ADA Curb Ramp New Construction Inspection Form (Parallel)

PARALLEL RAMP (PL)

PARALLEL RAMP (PL)

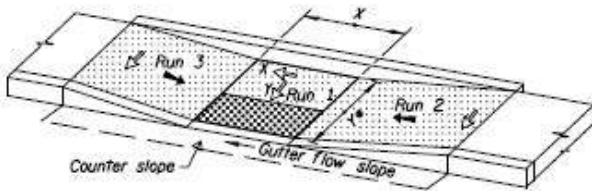
DWS IITD Fails turn space, RR to nowhere
